POST/HAZELTINE ASSOCIATES

1.0 INTRODUCTION AND REGULATORY FRAMEWORK

The Santa Barbara Museum of Natural History's proposed Master Plan project was the focus of a Phase 2 Historic Structures/Sites Report prepared by Post/Hazeltine Associates in April of 2014. The Phase 2 report was reviewed and accepted by the City of Santa Barbara Historic Landmarks Commission (HLC) in 2014. Conceptual plans for the Phase 1 component of the Museum's approved Master Plan were reviewed by Post/Hazeltine Associates in a letter report dated January 14, 2016 that was included in the package of material that accompanied the revised plan set reviewed by the HLC on January 27, 2016. This Letter Report Addendum evaluates revised final plans for Phase 1 of the Santa Barbara Museum of Natural History Master Plan (see Appendix A for plans).

2.0 EXECUTIVE SUMMARY AND PROJECT DESCRIPTION

Proposed Alterations to Owl Gates (Sheet A6.10)

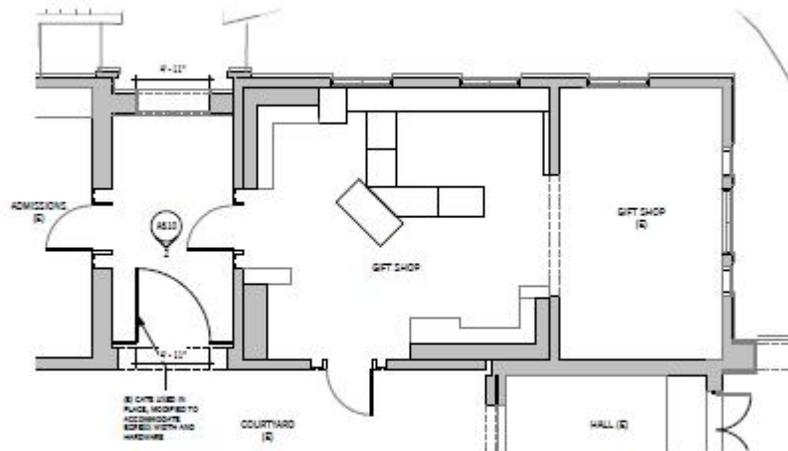
In order to meet to meet ADA and emergency egress code requirements egress hardware must be added to the metal gates embellished with owls set at the south end of the entrance corridor to the main Museum building (A6.10). These gates, which were originally located at another Museum building, were relocated to their current location sometime within the last 30 years and do not form a historic feature of the building. However, because the existing gates are made-up, in part, of historic ironwork featuring owl motifs, the proposed plan to convert the two gate leaves into a single leaf while preserving the historic metalwork including the owl motifs. In order to minimize physical impacts to the gate the hardware has been reduced to the minimum requirements including an egress push bar finished to mimic the color and finish of the existing gates that would set on the interior side of the gate and a solid steel kick plate finished to match the texture and color of matte black ironwork would set at the base of the reconfigured gate panels (A6.10).

The existing gates which are composed in part of decorative ironwork originally at the Education Department's library do not form a significant historic feature of the main building since they were modified and re-located to the main entrance less than 50 years ago. Consequently, the proposed scheme, which would preserve the owl motifs of the existing gate, which have been a
